Re: Florence Copper Project
Draft Underground Injection Control Permit R9UIC-AZ3-FY11-1

**Southwest Value Partners
Comments on
Draft Underground Injection Control Permit R9UIC-
AZ3-FY11-1
Issued to Florence Copper, Inc. for the Florence
Copper Project
Florence, Arizona**

Figure I-5. Well Inefficiencies in a Pumping Well

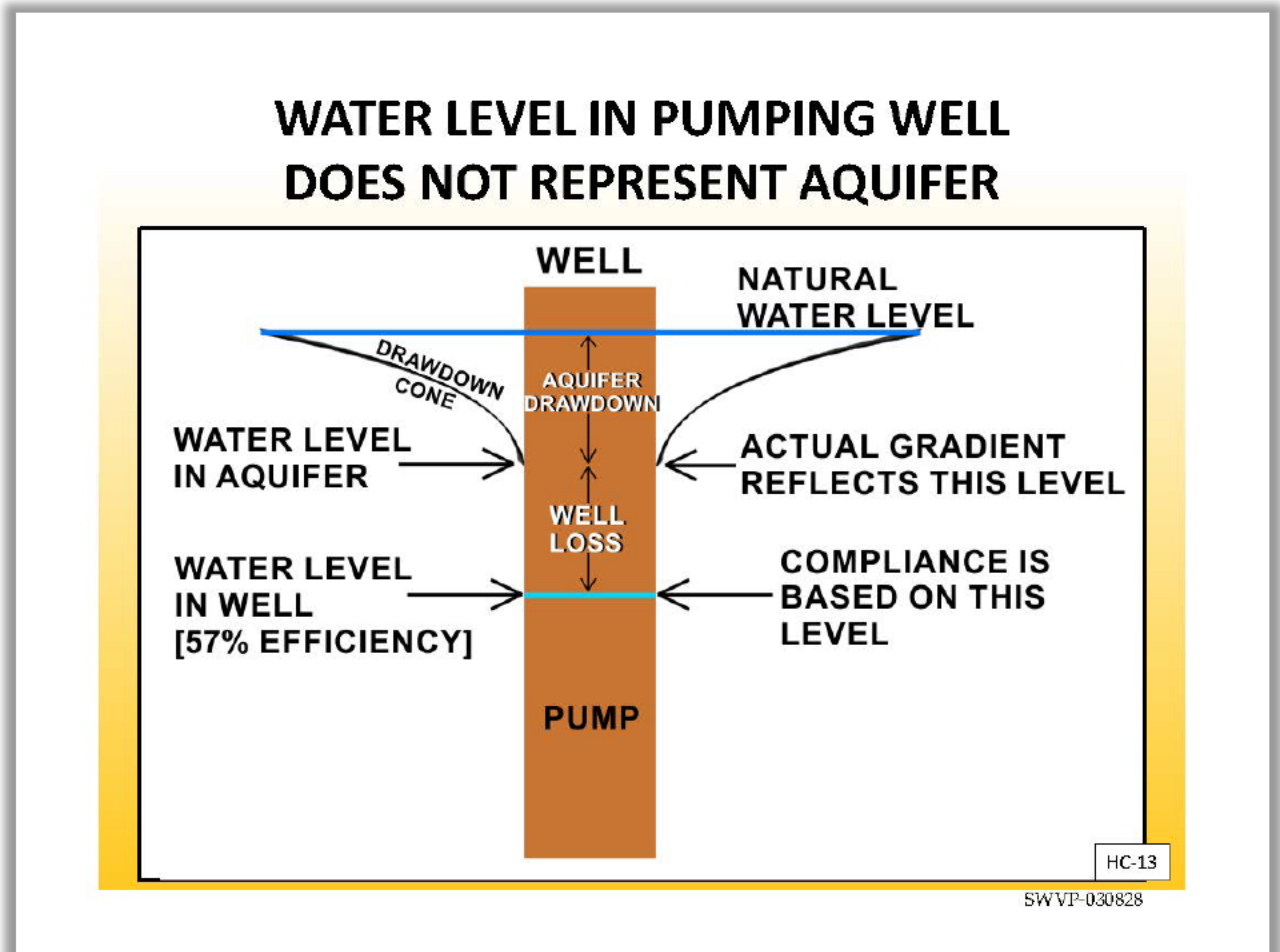
Third, the inward gradient unreasonably is based on measurement of water levels in FCI's wells, which are affected by well inefficiencies, instead of water levels in the aquifer. As depicted in Figure I-5 below, well inefficiency occurs because water levels are lower inside a pumping well than the water levels of the actual groundwater aquifer that it is intended to reflect.²²¹ As reflected in Figure I-6 below, this issue is well understood by EPA and should have been incorporated into the permit requirements.²²²
